**MOUNT POLLEY MINING CORPORATION
MOUNT POLLEY MINE
TAILINGS STORAGE FACILITY
REPORT ON 1999 CONSTRUCTION
(REF. NO. 11162/13-5)**

REPORT ON 1999 CONSTRUCTION

STAGE 2C DESIGN MODIFICATIONS

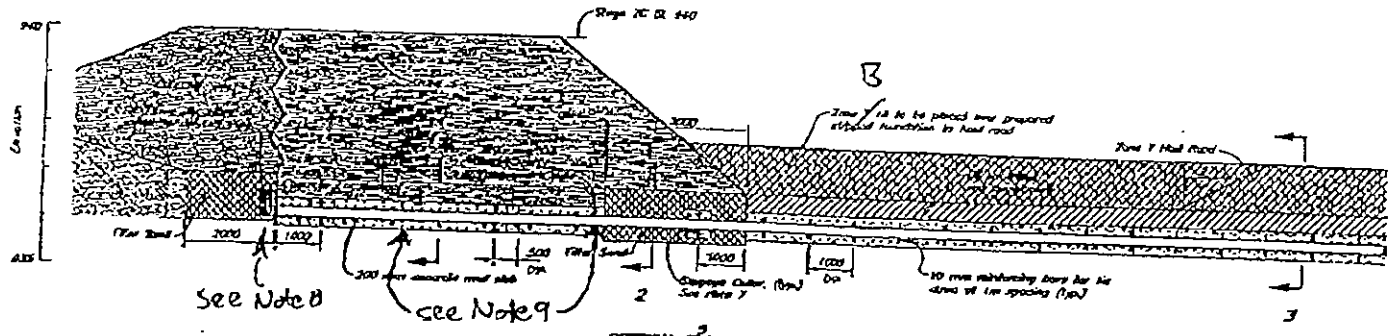
The attached three design changes have been approved with one amendment. The vertical risers that were proposed for the upstream toe drain outlets introduce too much rigidity in the system and the pipe could shear under differential settlement. Instead, a "sweeping bend" could be used to accommodate elevation differences. The sweeping bend or horizontal elbow are flexible in the plane of expected forces and would accommodate settling without damage to the pipe. This need for making up an elevation difference between the toe drain and the outlet should not be required any more as the toe drain is going to be installed first at a known elevation (936 m) and the outlet should, therefore, be installed accordingly. You should send in a design change request for the revised upstream toe drain installation as I discussed with Eric yesterday.

Please review the proposed change / substitution as per the attached sheets.

Proposed change / substitution not approved:
approved as submitted: ✓
approved as amended: _____

MOUNT POLLEY MINING CORPORATION		
MOUNT POLLEY MINE		
STAGE 2C CONSTRUCTION MAIN EMBANKMENT APPROX. CH 15+60 TO CH 26+80		
Knight Piesold CONSULTING	PROJECT NO. 11162/10	REV. NO. - 0
		FIGURE 1

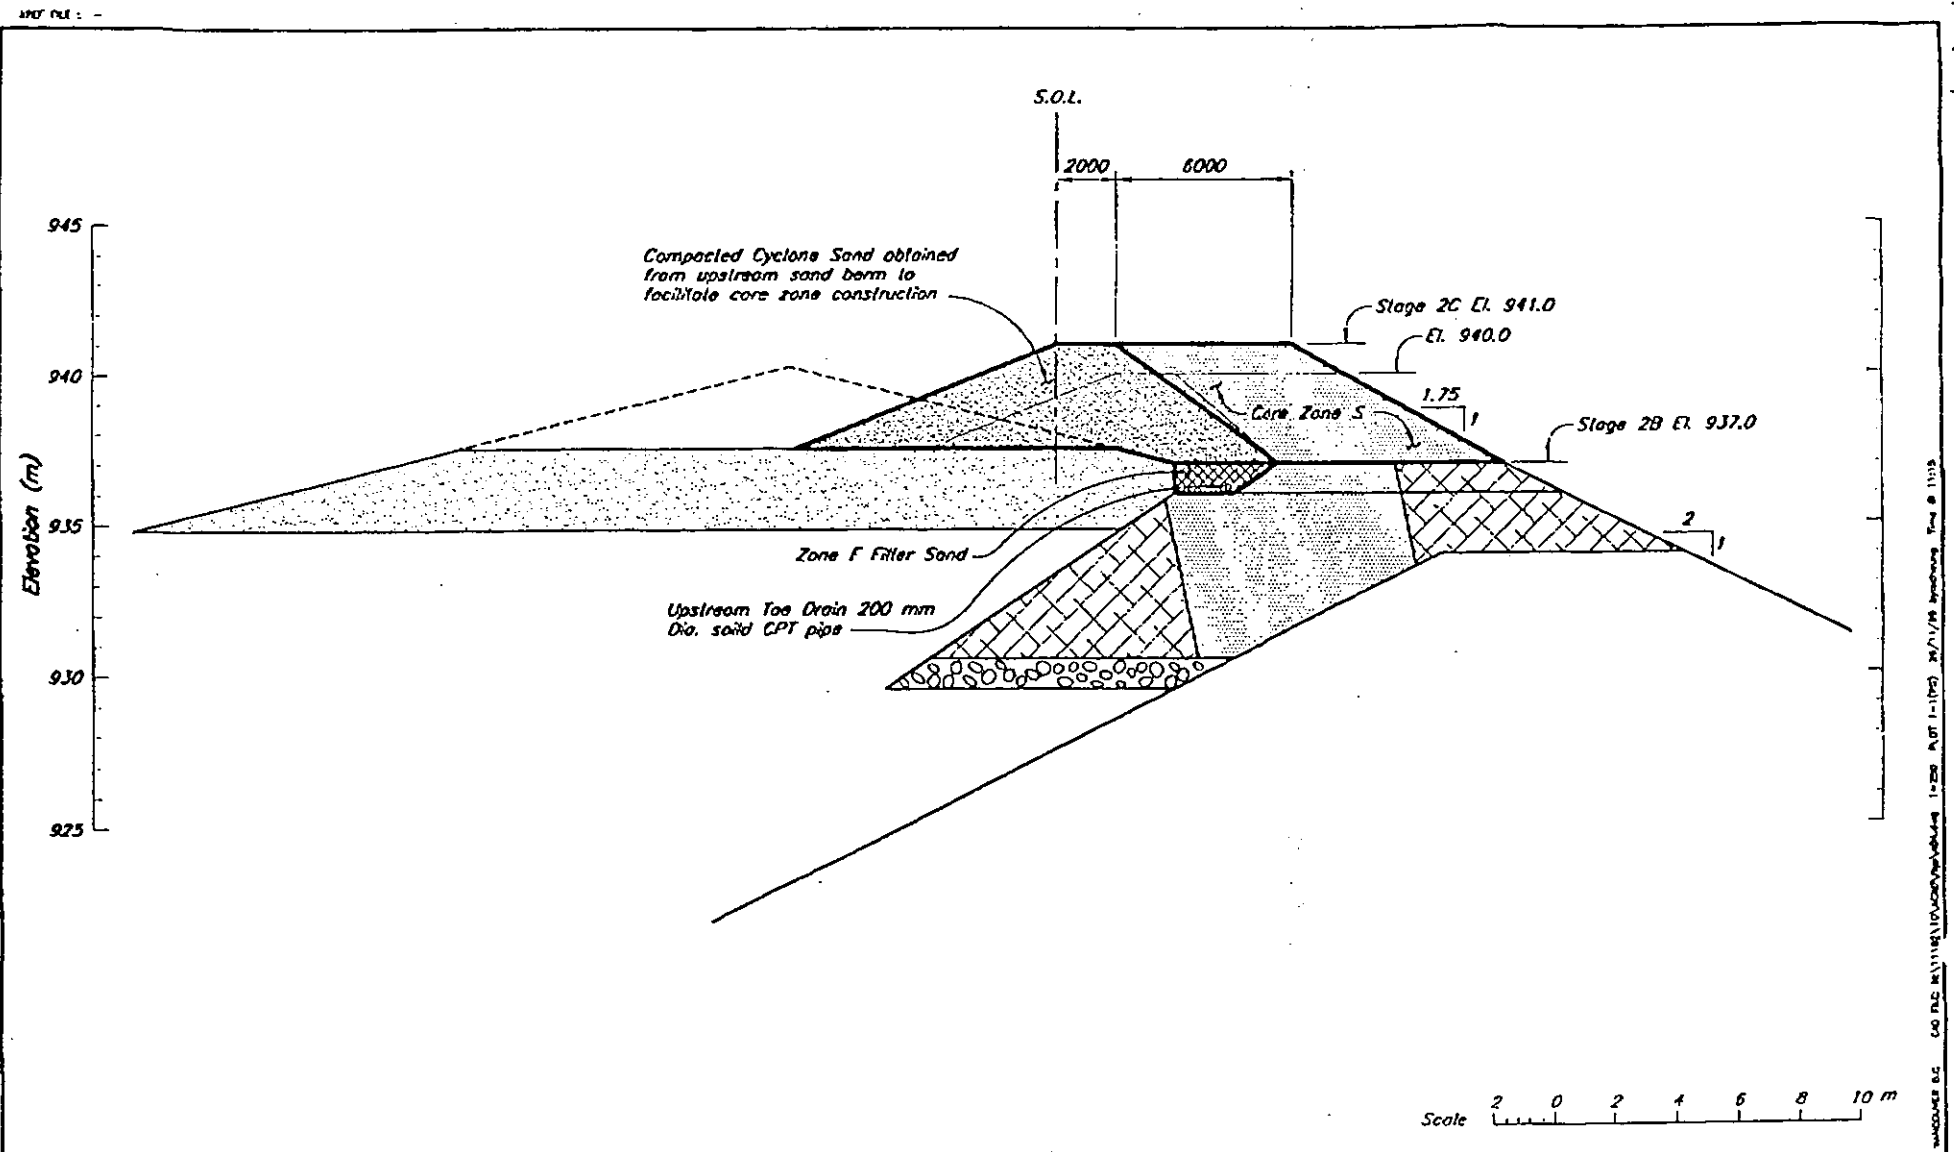
Reference Drawings/Clauses: Figure 1 - Main Embankment (± CH 15+60 to 26+80)
Figure 2 - Main & Perimeter Embankments (± CH 26+80 to 32+00)
Figure 3 - Perimeter Embankment (± CH 32+00 to 44+35)

Attached is your submitted design change request, which has been approved as amended. The approved design change is described as follows:

FIGURE 1

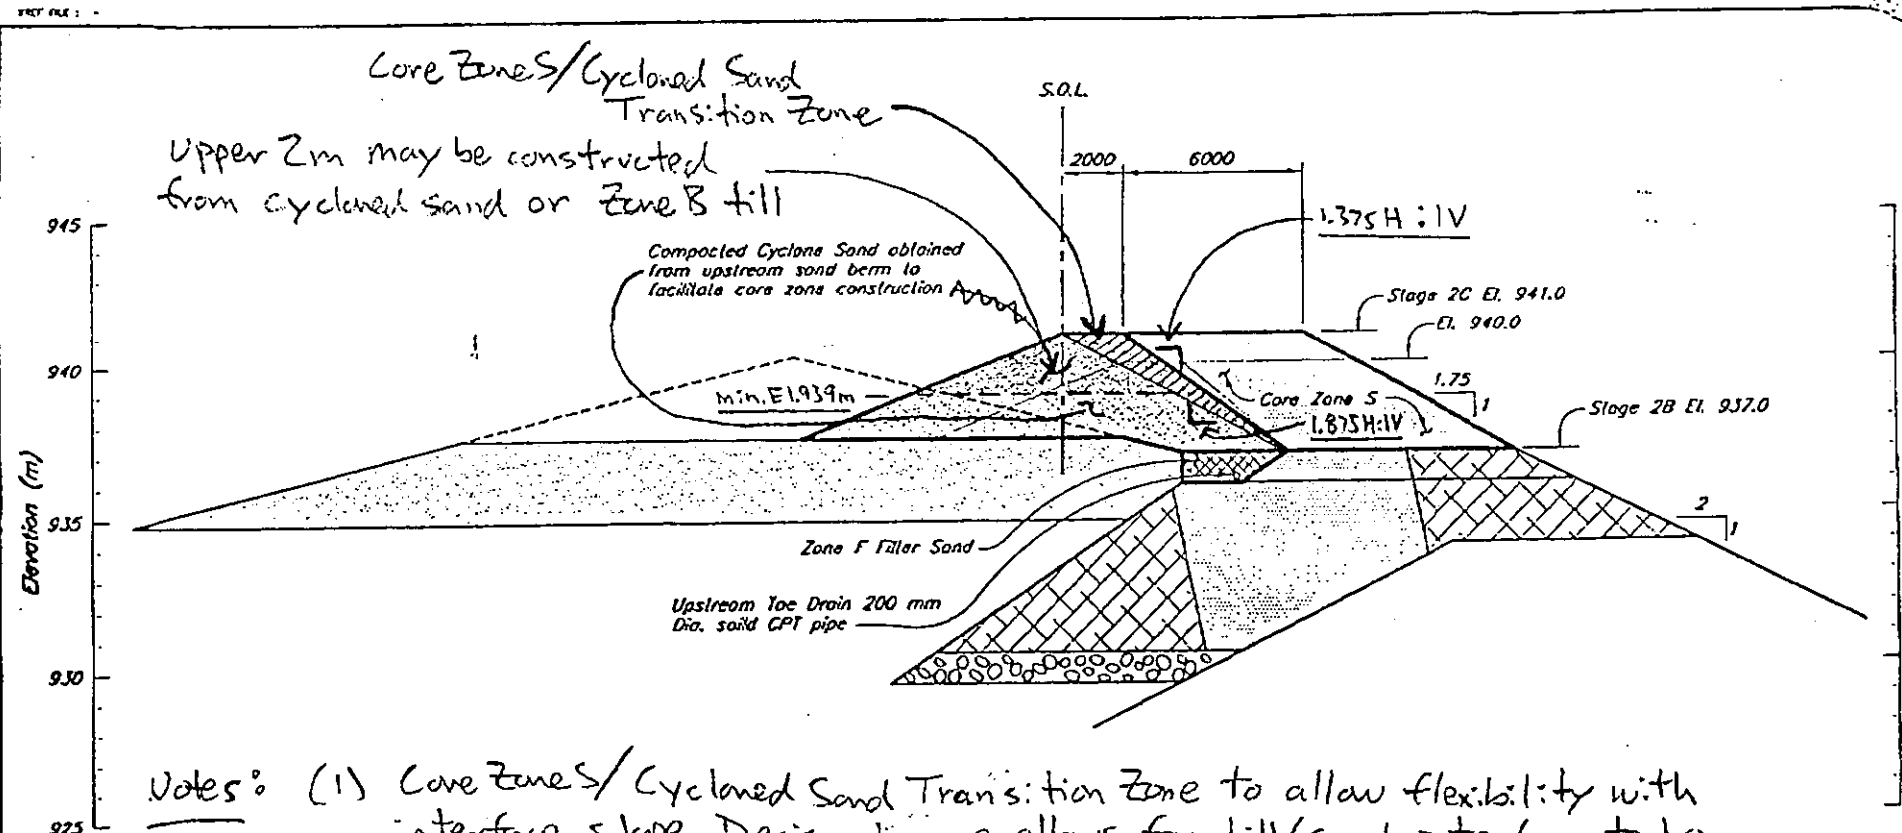
Reference Drawings / Clauses: Figure 1 Rev. 0 of Design Change, issued by KP Vancouver (Nov 26/99, Ref No. 9/2771)
